## PLANNING REPORT

# Architectural Review Board

## 40 E. BRIDGE STREET 24-022INF

Address	40 E. Bridge St, Dublin, OH 43017
Proposal	Informal review and feedback for the remodel and construction of additions to 40 E. Bridge Street on a 0.31-acre site zoned HD-HR, Historic Residential District. The property is located northwest of N. Riverview Street and E. Bridge Street.
Request	This is a request for non-binding review and feedback for future development applications.
Zoning	HD-HR, Historic Residential District
Planning Recommendation	<u>Consideration of the Discussion Questions</u>
Next Steps	Subsequent to informal review and feedback, the applicant may apply for a Minor Project Review (MPR) with the Architectural Review Board.
Applicant	Kelly Burke, Owner David Knapp, Tandem North Design
Case Manager	Sarah Tresouthick Holt, AICP, ASLA , Senior Planner 614.410.4662 <a href="mailto:sholt@dublin.oh.us">sholt@dublin.oh.us</a>

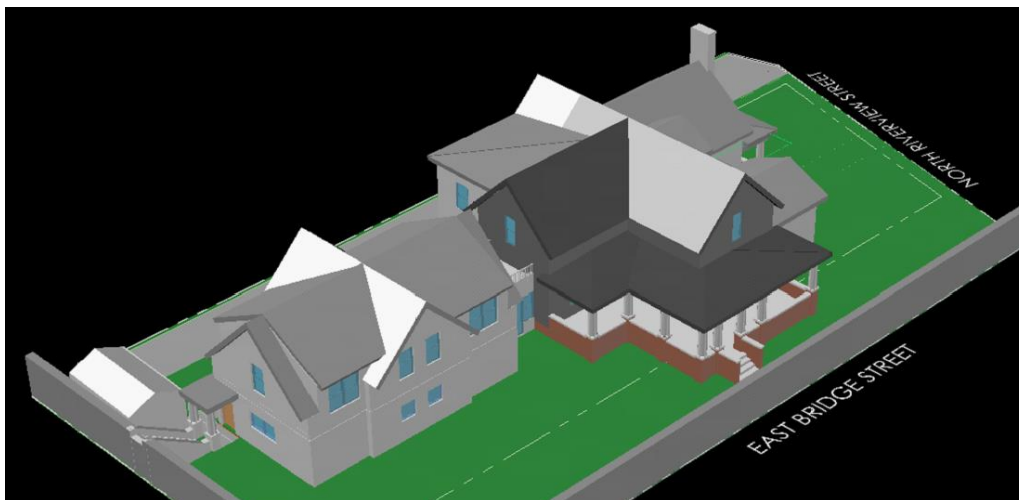
Code Table 153.173A of the Code governs permissible lot coverage, building footprint sizes, and setbacks for all districts within Historic Dublin. For Historic Residential, the table indicates up to 45 percent lot coverage is permissible; the building footprint may be up to 25 percent of the lot size; and the rear setback is 20 percent of lot depth, not to exceed 50 feet. A survey is required at MPR to ensure accurate numbers. The maximum ADU size is 800 square feet, per Code Section 153.172(4)(d)(2).

The existing lot area is 13,180 square feet. The lot depth, if the Board is in agreement with using the north property line as "rear", is +/- 84 feet on the east/west sides.

The Board is requested to comment on these Waivers.
